ENVIRONMENTAL IMPACT REPORT
FOR THE PROPOSED
SKY RANCH II RESIDENTIAL SUBDIVISION
IN UNINCORPORATED CONTRA COSTA COUNTY
PITTSBURG, CALIFORNIA

Final EIR
September 2006

City of Pittsburg
Planning Department
65 Civic Avenue
Pittsburg, CA 94565

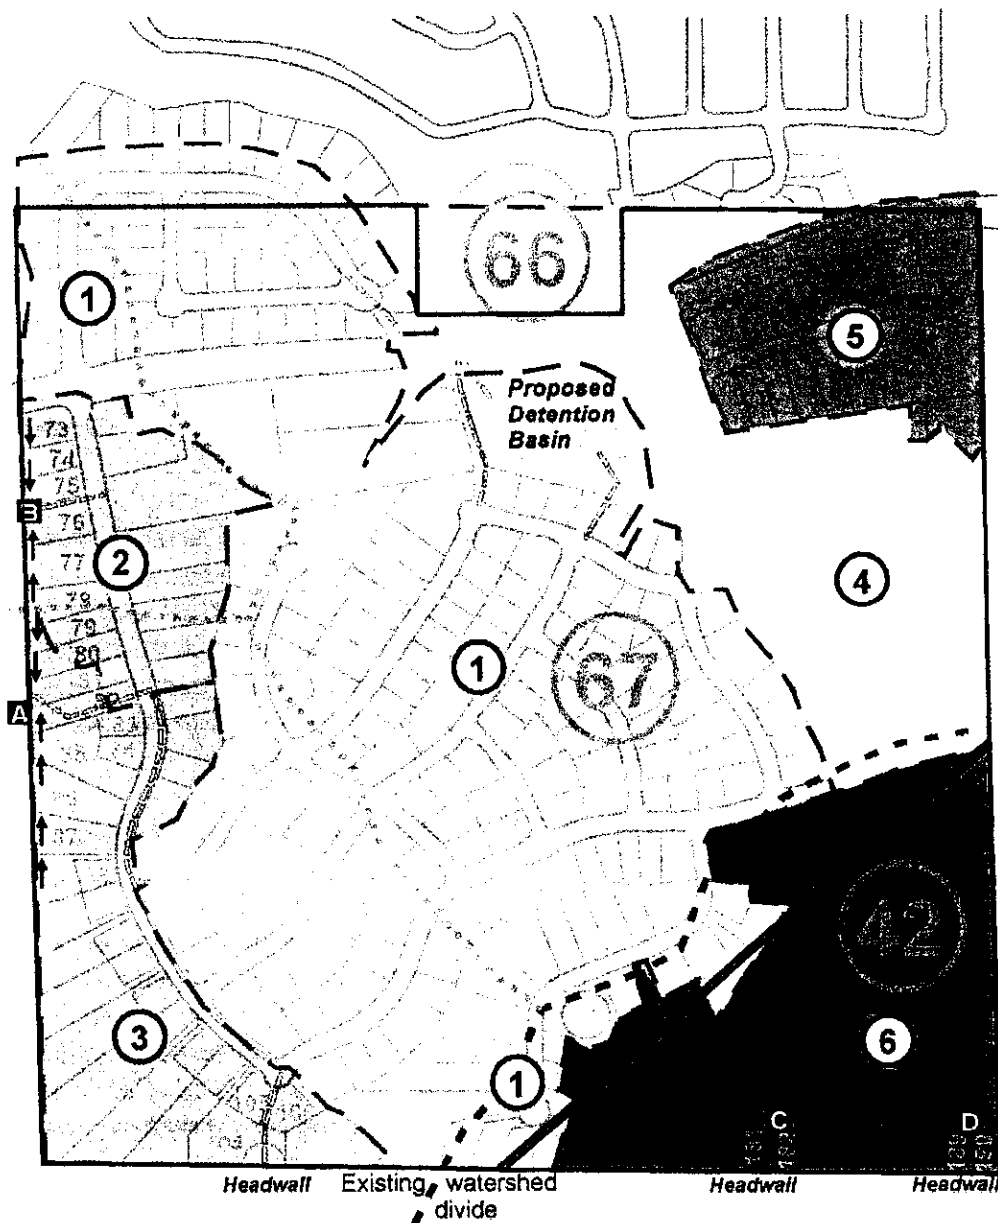
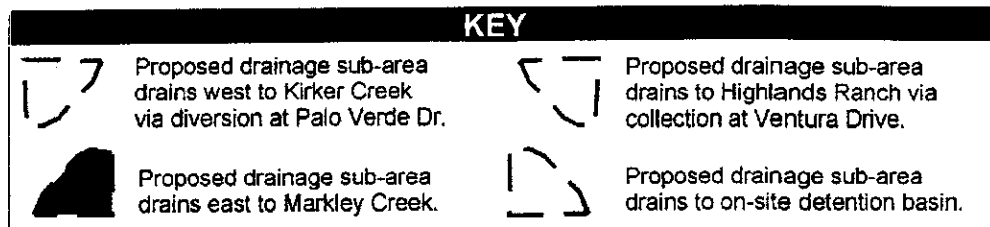
District staff requests a copy of the draft final subdivision map so that the District may determine the Drainage Area 55 fee obligation for the portion of the project site located within Assessor Parcel Number (APN) 089-050-042. According to the District's comment, the City of Pittsburg will need to collect this fee during the development process, before recording of the final map, and forward the fee collected to the District.

The entire 19.28-acre parcel, APN 089-050-042, is outlined in red in Figure 14 (next page). APN 089-050-042 is located within the southeastern corner of the project site. This portion of the project site, which drains east to Markley Creek, is included in the watershed known as the West Antioch Creek watershed.

The City of Pittsburg Engineering Department staff notes that the City cannot collect the Drainage Area 70 fee on behalf of the District. The entire 136.85-acre parcel, APN 089-050-067, is outlined in green in Figure 14 (previous page). The "notch" at the north end of APN 089-050-067 is APN 089-050-066, which is a City-owned parcel consisting of 3.87 acres improved with a water reservoir.

Most of APN 089-050-067 is located in the watershed known as the East Kirker Creek watershed. As apparent in Figure 14, the existing watershed divide between the East Kirker Creek watershed and the West Antioch Creek watershed falls generally within APN 089-050-067, near its southeastern limit. The proposed project grading would alter the existing watershed divide, slightly reducing the area tributary to the West Antioch Creek watershed to 22 acres in drainage sub-area 6 (see Figure 14).

Figure 19 (on the following page) illustrates prominent slopes that would be subject to mitigation measures described in the response to Comment J17-1. Please refer also to the responses to Comments B4 and B5, pages 36-39.

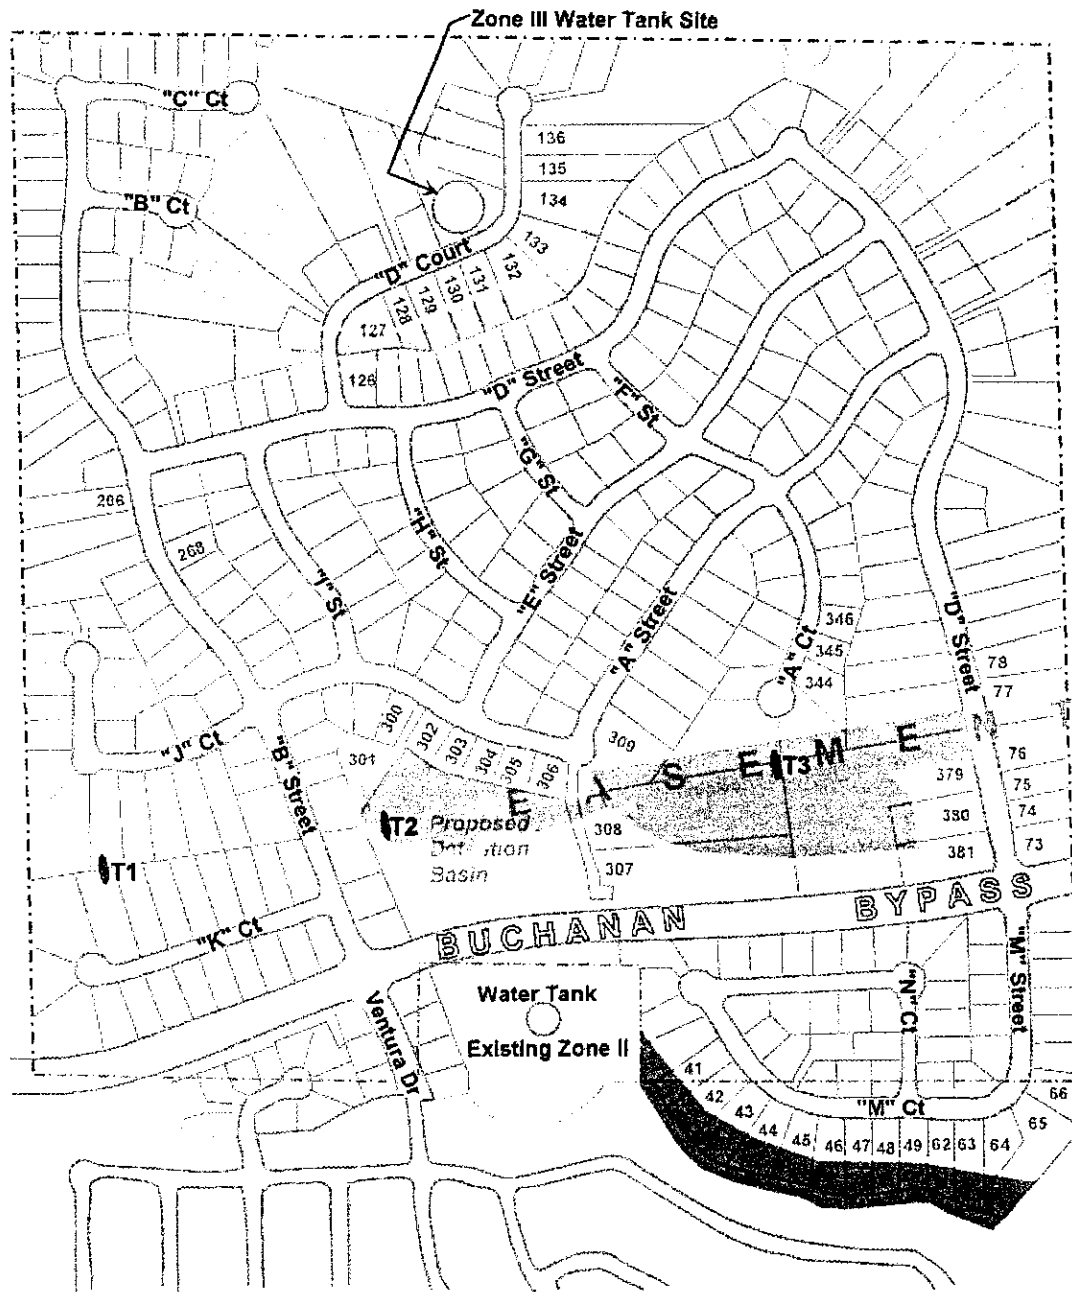
- 8) Figure 19-Visually Prominent Slopes is inaccurate – a casual look at Google Earth shows that the property is a bowl with a horseshoe shaped ridge encircling the property, the ridges crowned with fire roads—Is the assumption that grading has already taken place and these are the "Visually Prominent Slopes" that are left? The analysis should show the "before" condition. (V-175) J17-8

The comment expresses an opinion that Figure 19 and the visual analysis are inadequate.

Figure 19 (Draft EIR, p. V-175) is intended to show visually prominent slopes after the proposed grading. The purpose of Figure 19 is to provide detail in regard to slopes that should be subject to mitigation measures described in the Draft EIR, p. V-180. These measures are intended to mitigate the appearance of opaque fencing and introduced landscape species on these visually prominent slopes.

VIEW 3: Ventura Street and Buchanan Road - Existing

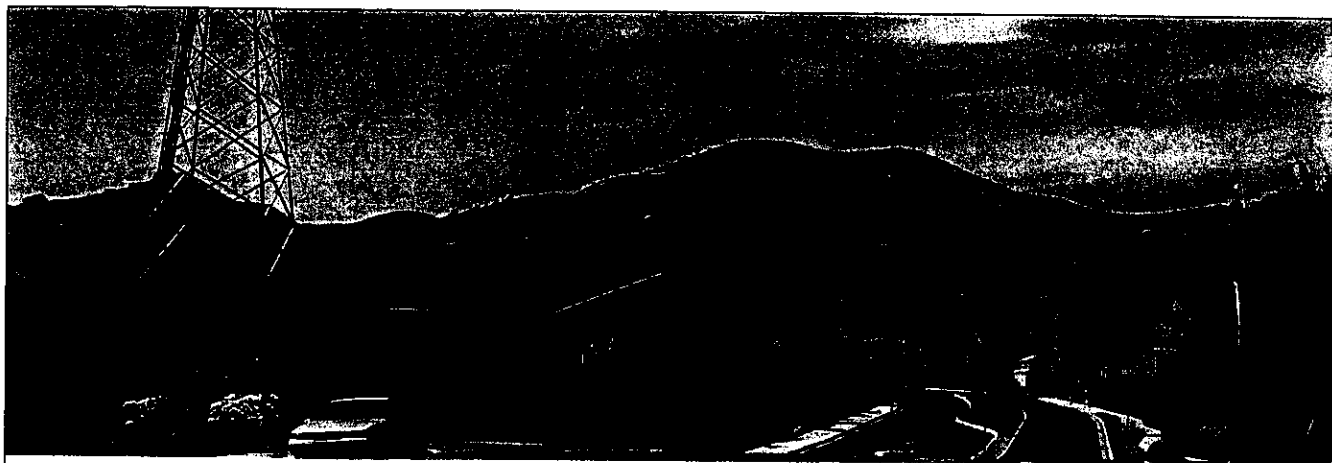
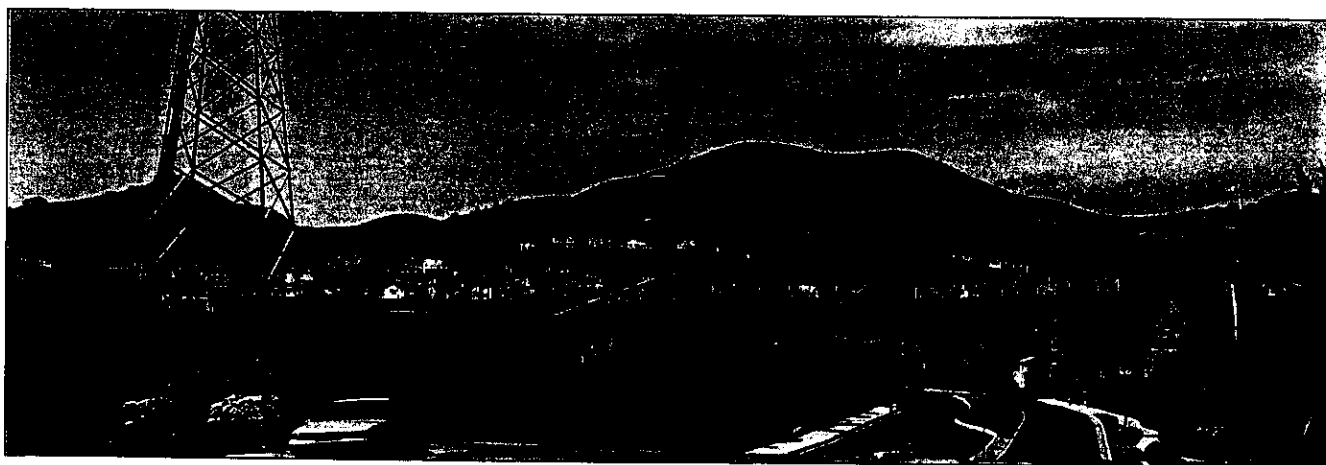
The comment is a question why the “post development” photo-simulation is not printed with the “pre-development” photograph. The comment also expresses several opinions about the visual analysis in the Draft EIR.

Existing pre-development and post-development views are shown below:

After careful evaluation of the existing visual resources, City of Pittsburg Planning Department staff determined that visual simulation of the existing vistas or panoramic views of the Suisun Bay/Sacramento River Delta, as viewed from Black Diamond Ranch Regional Preserve could not be affected by the proposed project. These vistas would remain intact, uninterrupted by any of the proposed houses on the project site. Refer also to the response to Comment B5 on pages 34-35.

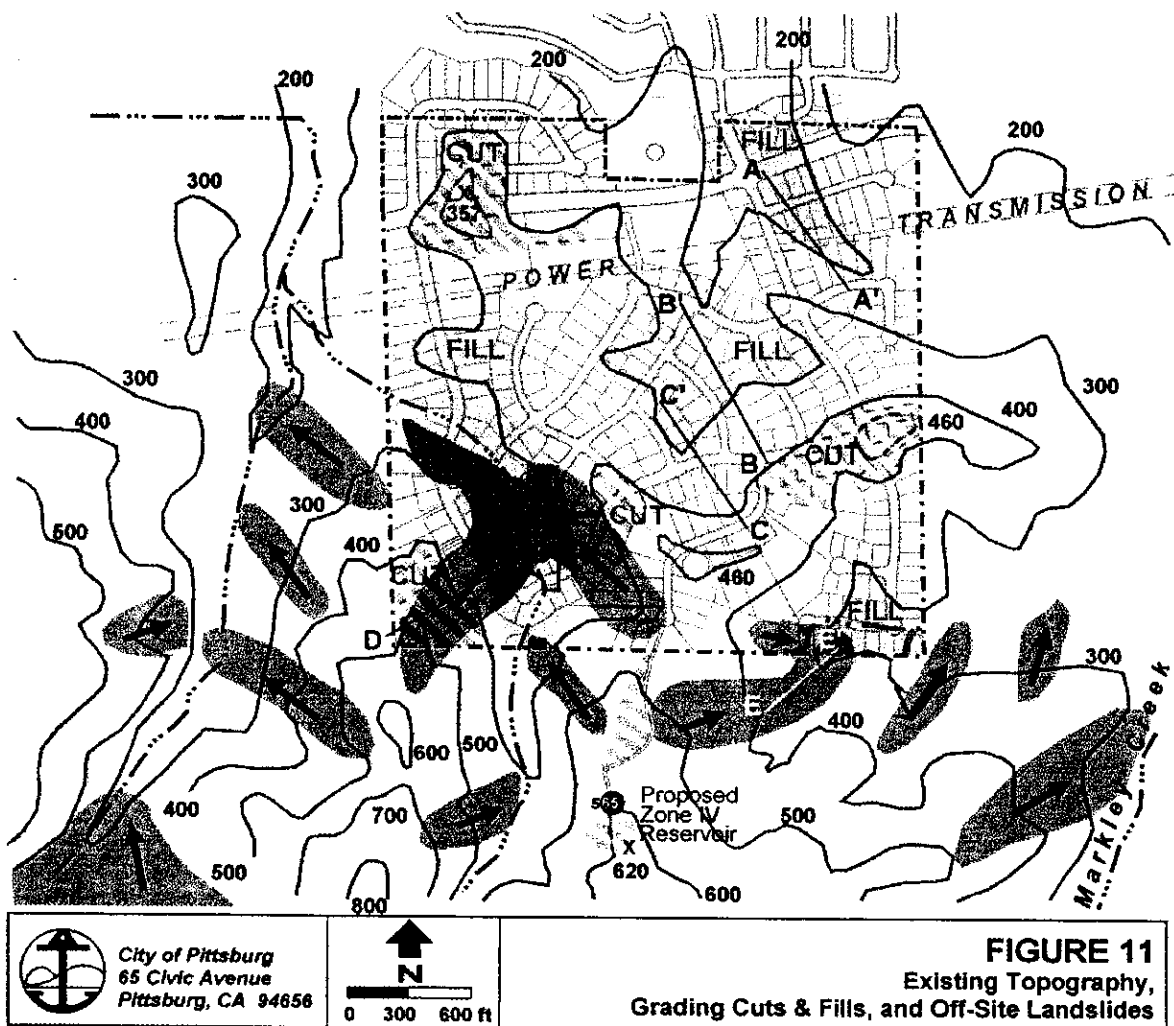
The comment is that none of the graphics in the Draft EIR shows the location of the off-site 1-million gallon Zone IV water reservoir.

Figure 11 (Draft EIR, p. V-119) shows the proposed Zone IV reservoir and shows generally, in a simple way, existing elevation contours and areas of proposed grading cuts and fills. The “horseshoe-shaped ridge” as described in Comment J17-8 is at elevation 400-460 feet msl. The “bowl” as described in Comment J17-8 would be filled as shown below.

FIGURE 21

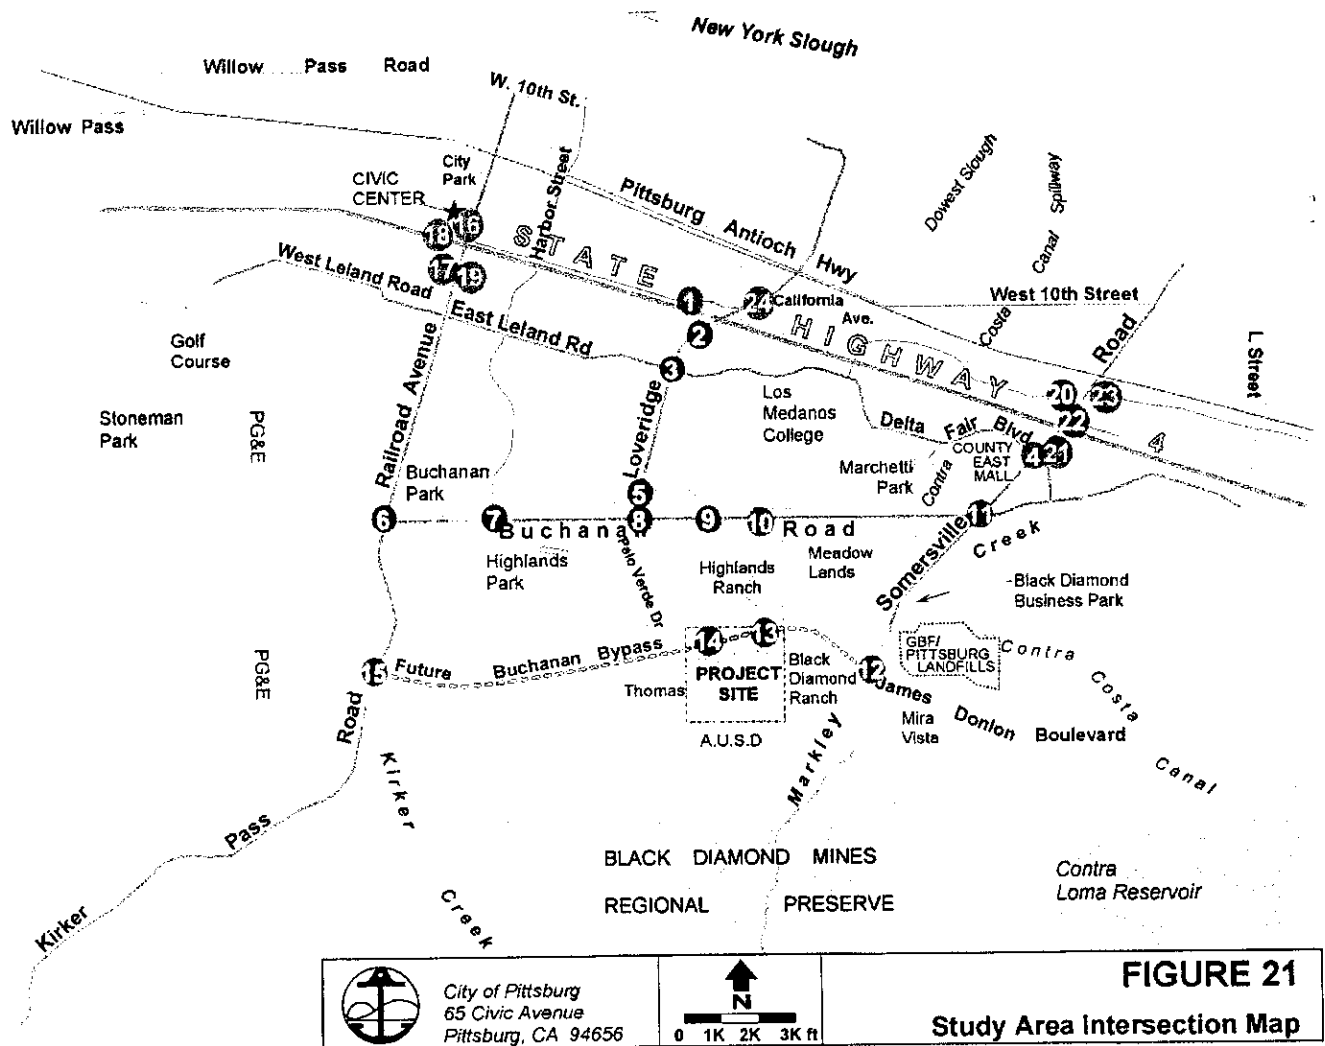
intersection). The mitigation measures for Impact 1 on page V-255, do not show the intersection Level of Service (LOS) for the queue on the State Route 4 (SR 4) westbound off-ramp. A traffic simulation analysis needs to be conducted to investigate queuing for each of the following "impact" intersections: Impact H1 and H2 on page I-28, Impact H21 and H22 on page I-32, Impact 2 on page V-255, and impact 21 and 22 on page V-262. In addition, we could not locate Figure 22 that is referred to on page V-241.

The California Department of Transportation (Caltrans) commented that Figure 22 was not available or could not be found.

Figure 20 illustrates study area intersections, and Figure 21 illustrates existing peak hourly and daily traffic volumes. Figure 20, p. V-240 (correctly labeled as Figure 21), and Figure 21, p. V-242 (correctly labeled as Figure 22), have been appropriately re-labeled and are included in the Final EIR, Chapter V.H, Traffic & Circulation, for clarification.

Figure 21 illustrates study area intersections and is incorrectly numbered as Figure 20. It should be labeled "Figure 21" as herein (p. 216). The figure has been amended to show additional intersections identified by Caltrans.
